Riverside Energy Park

Statement of Common Ground: Environment Agency

8.01.03

May 2019 | Revision 0 (Deadline 2)

Drawing Title:
Flood Defence Layout
Existing Wall Types - Sections
INDICATIVE POSSIBLE OPTIONS

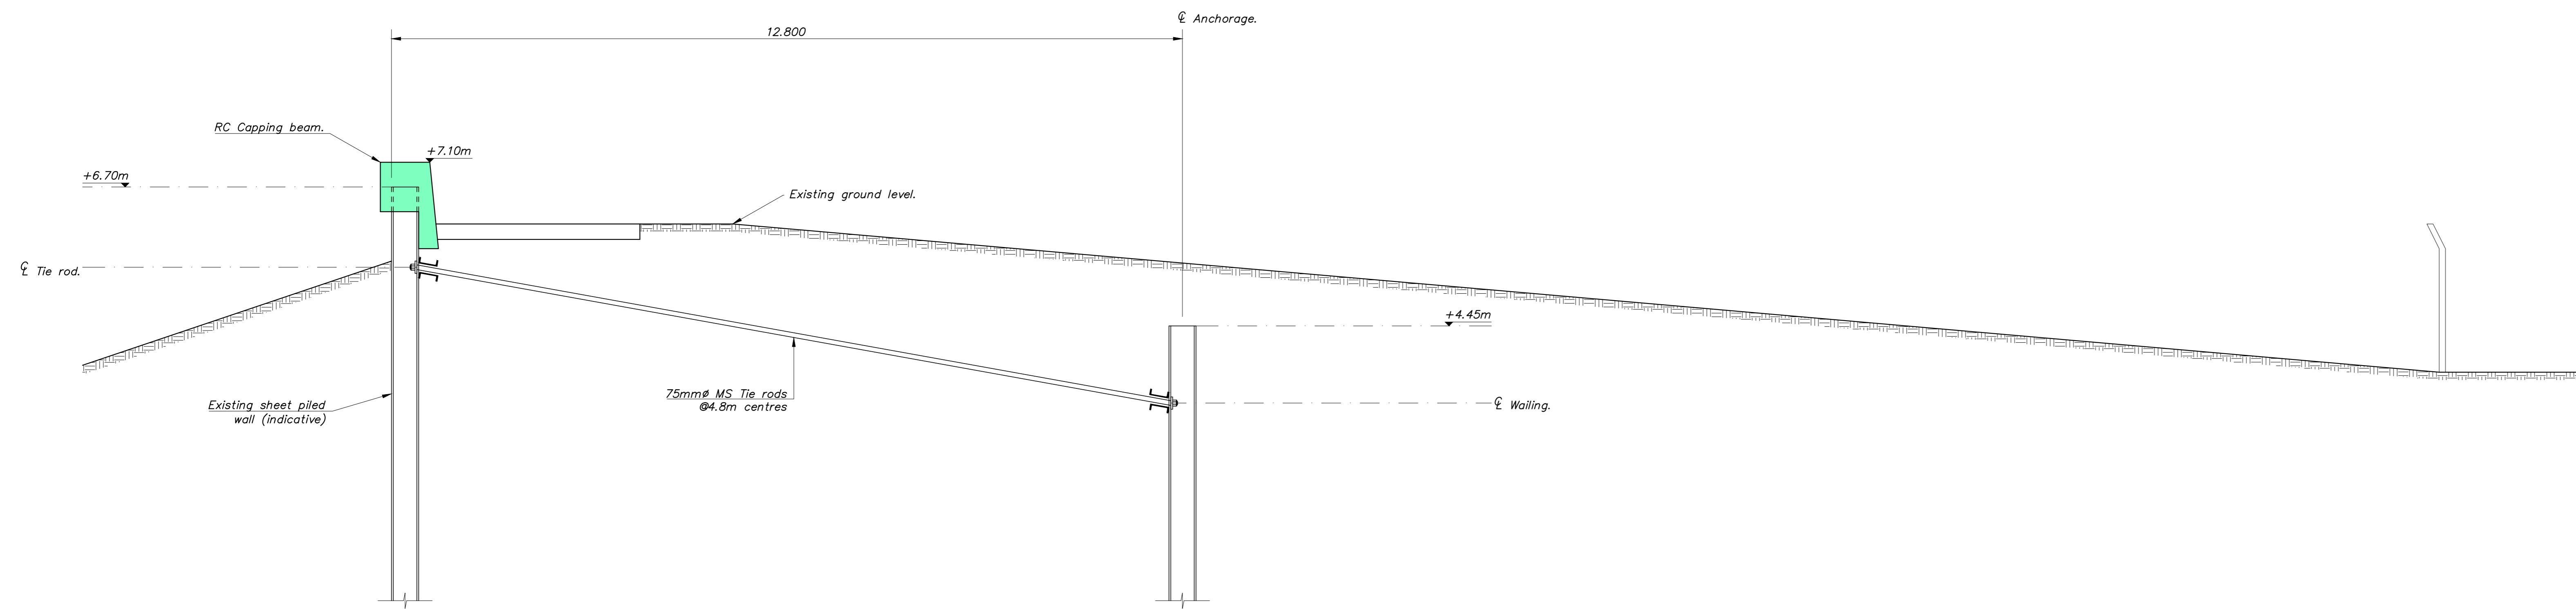
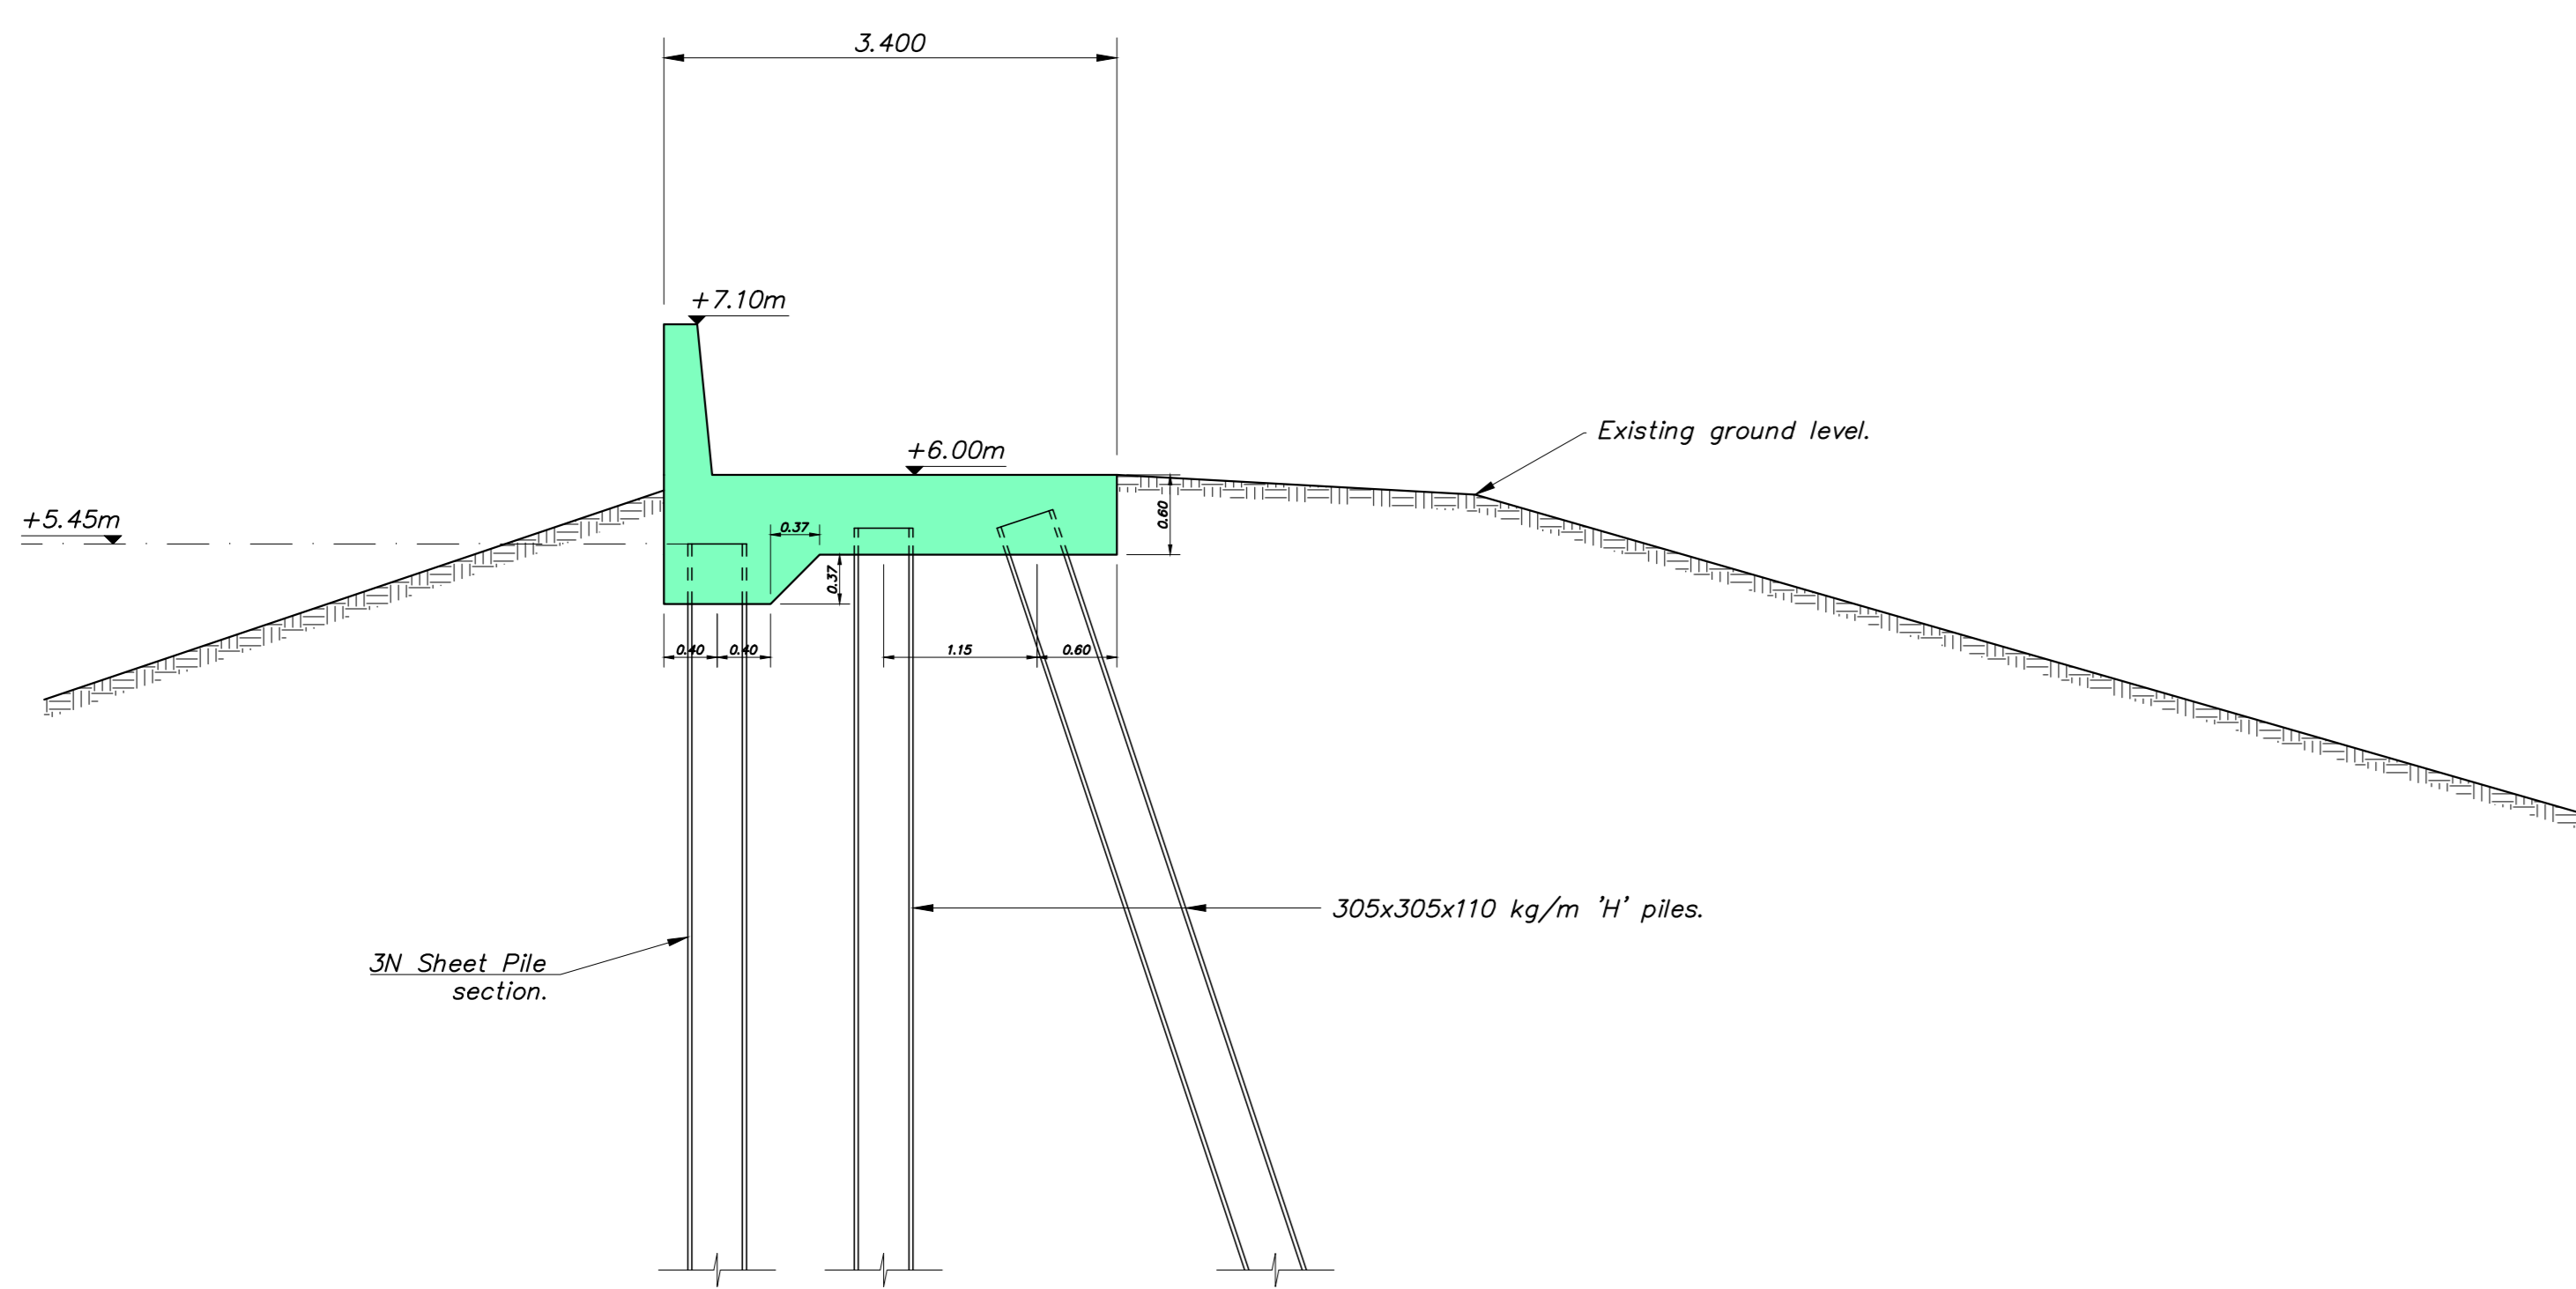
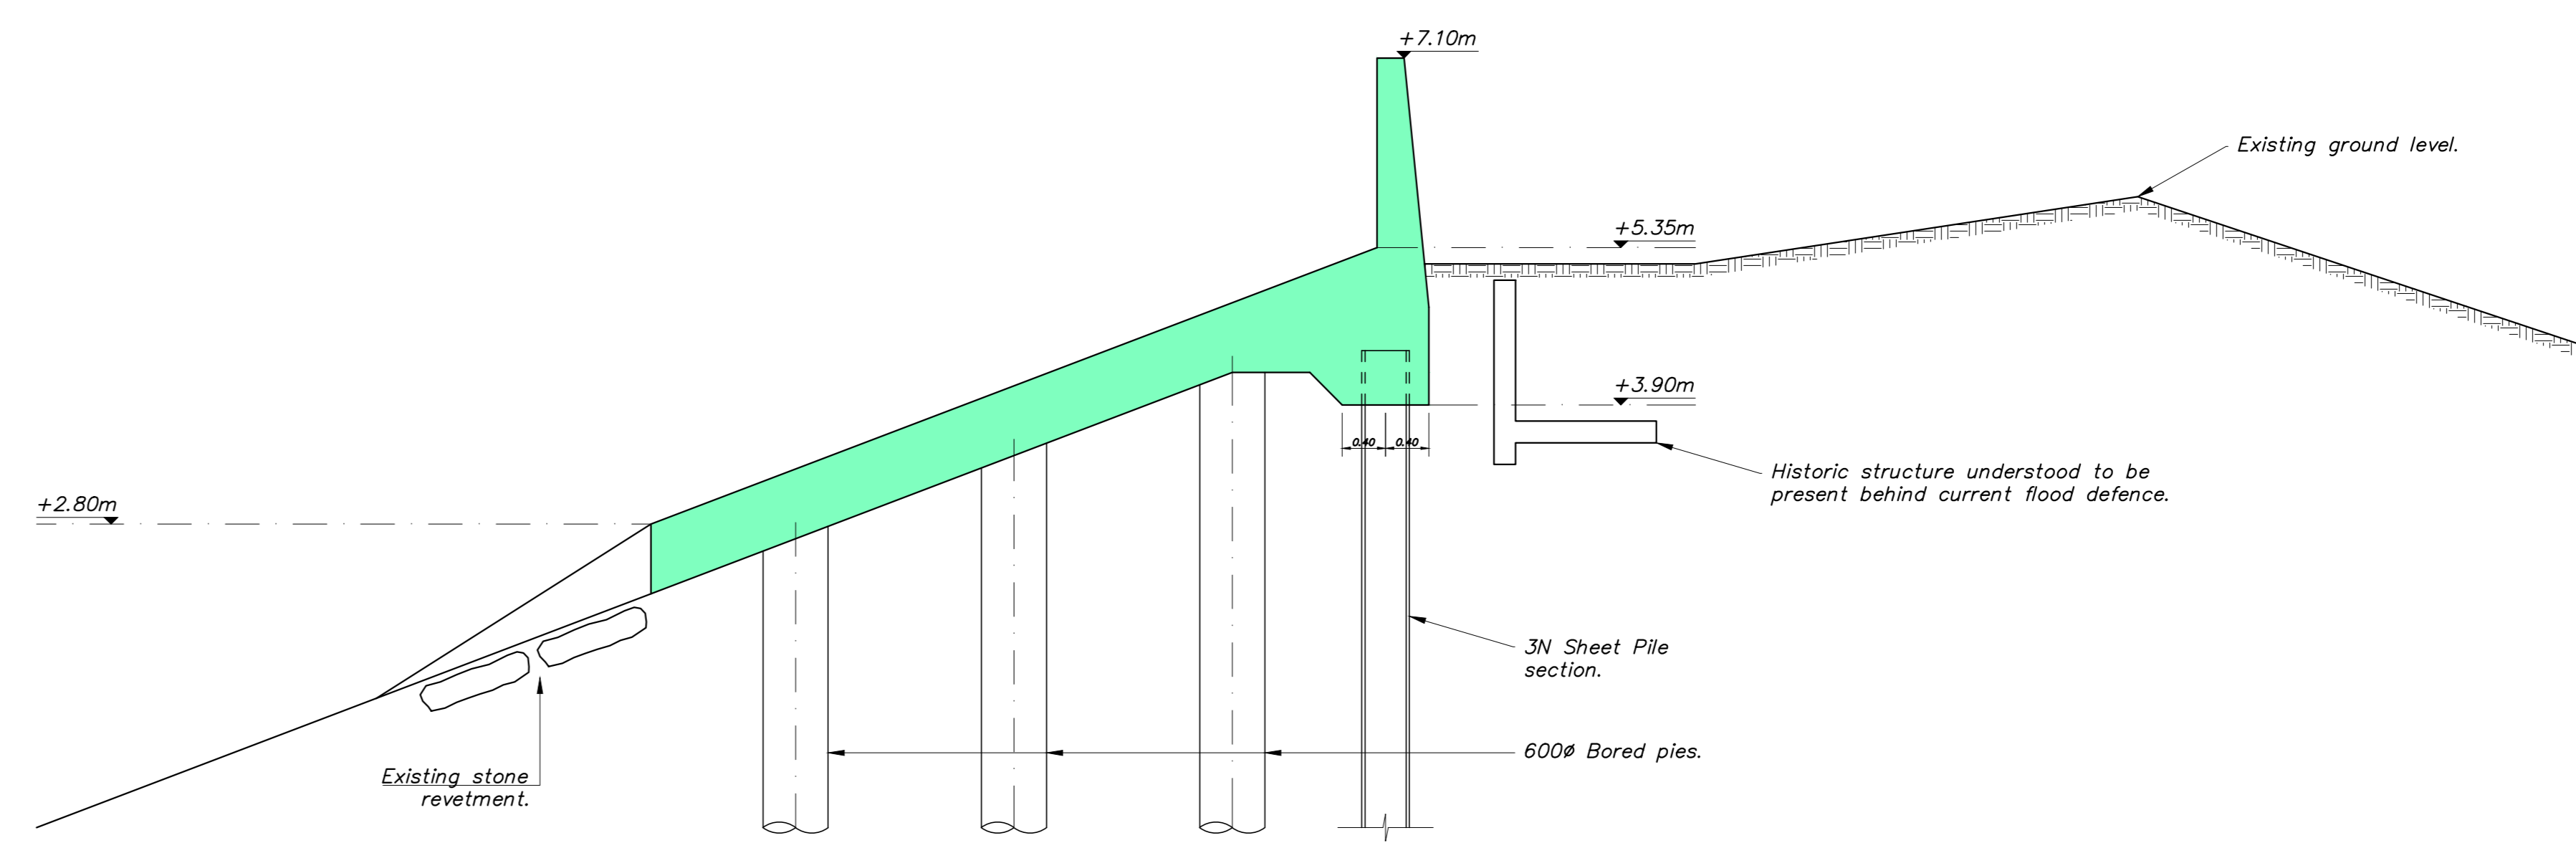
2.2.1 Through the indicative diagrams C110-113 (appended to this SOCG), the Parties agree that it has been demonstrated that the Proposed Development does not preclude the raising of the flood defence to the second stage level (of 7.7m AOD expected in 2070) proposed in the Thames Estuary 2100 Plan, and does not significantly restrict future defence raising options. These illustrative drawings were provided at the request of the EA in order to provide examples of technical solutions that could be adopted in the future should the need ever arise to raise the flood bank in line with the requirements of the Thames Estuary 2100 Plan.
